Council Response to comments on HA23:

Ref: Council Response EX15

Church Cliff Drive, Filey – SiteHA23 (Flooding Information).

***From Filey Town Council. Filey FAS. Presentation to Planners 15.02.2016.
SBC and Royal Haskonig DHV. Page 21, How it works – North Area – With Scheme.***

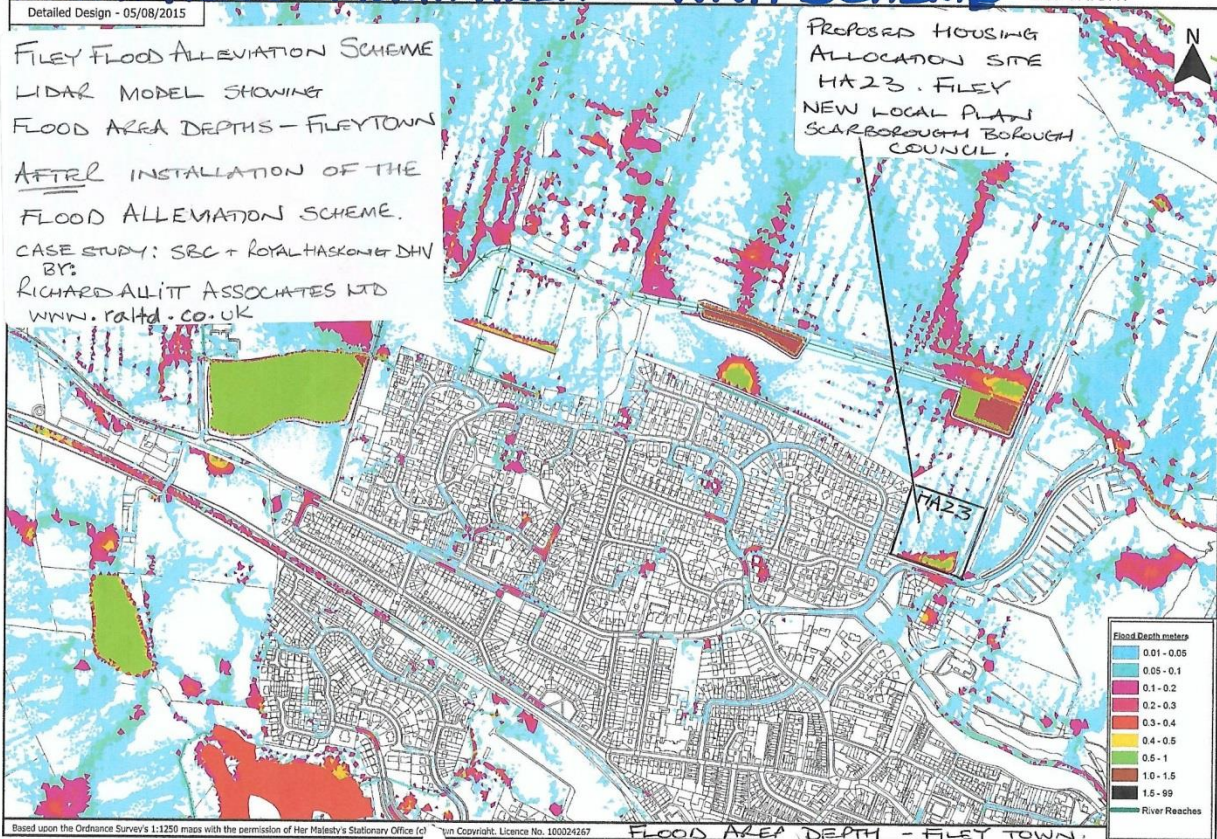
Even after completion of the FFAS, the area HA23 will still meet the definition of being in a flood zone 3b as explained in the SFRA 6.2.2. The Lidar model clearly supports this assertion.⁴ This highlights the area of storm water storage /ponding and shows flood depths could be Between .5 to 1 meter deep at times of flooding. This area would not pass the assessment for a high risk flood zone following the NPPF, PPG Policies and SFRA.

Even with the Filey Flood Alleviation Scheme in place, the southern end of HA23 will be exposed to flood protection flood water storage/ ponding⁹. So development will incur costs of a storm water attenuation system, which links to the viability of the development.

Due to the technical design of the Filey Flood Alleviation Scheme the residential areas around site HA23 will be fully protected from potential flooding. However, according to the Lidar Model¹¹ submitted it is clear that HA23 will be subject to flood protection flood water storage/ ponding and will therefore still remain classified as a flood zone 3b.

Council Response: *Some explanation of what the LIDAR model is and actually highlights would be of assistance. The following is that which has been provided by SBC Engineers to understand any implications.*

LIDAR is a means of achieving accurate topographical analysis of an area using a flyover. The results can be used for several purposes and in this instance used to model the impact of the Filey Flood Alleviation Scheme and the impacts of future rainfall events with this in place. The LIDAR model, as the respondent states, shows an area of ponding (not flooding) to the south of the site, the result of potential rainwater falling onto the site directly. This is based on the approved

planning proposal which included a bund to the southern boundary of the site and clearly demonstrates that its inclusion would benefit residents of Church Cliff Drive by slowing/preventing further overland flow of rainwater to those areas. Without the bund, water would flow into surrounding areas but obviously to a lesser extent than today due to the installation of the FFAS.

However, it should be noted that the LIDAR model and the flows superimposed onto it are not a reason for refusing the development of the site for housing. The role of the bund would no longer be required as the housing development itself would perform the same role, potentially to a greater degree.

SBC Drainage Engineers confirm that the development of the site with a suitable means of positive drainage (as has been successful on other schemes across the Borough) will further protect the surrounding areas from future flood incidents by capturing rain and groundwater, storing it and allowing it to be positively drained at a pre-determined rate of flow, hence the bund would no longer be required.
